Access Compliance Report Public Rights-of-Way (Curb Ramps)

Main Street: CONTIGO_PL Cross Street: AMADO_PL Location: SW

ADA ID: RPRK211117161315 Ramp Type: Type 4 - Parallel Initial Pass/Fail: Pass Overall Compliance: No Severity Score: 5

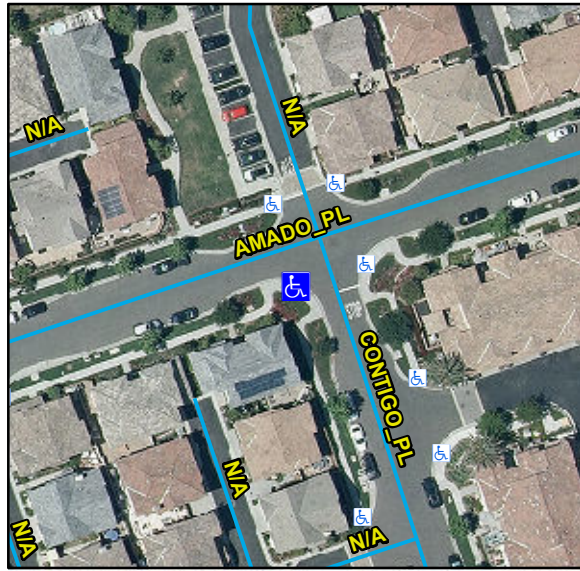
Crossing 1 Slope (%)	1.5		Crossing 2 Slope (%)	0.1
	Crossing 1 Cross Slope (%)	1.3		Crossing 2 Cross Slope (%)	0.6
Yes	Gutter Ponding	No	Yes	Curb Slope	7.9
Yes	Gutter Lip Height (in)	0		Road Run Slope (%)	1.2
No	Gutter Run Slope (%)	10.1		Road Cross Slope (%)	1
Yes	Gutter Cross Slope (%)	0.5	Yes	Perpendicular Joint Present	Yes
Yes	Overall Surface Condition	Acceptable			
	Cross Gutter Present?	No		Spandrel Present?	No
	Replace Cross Gutter?	N/A		Replace Spandrel?	N/A

Remove & Replace Gutter.
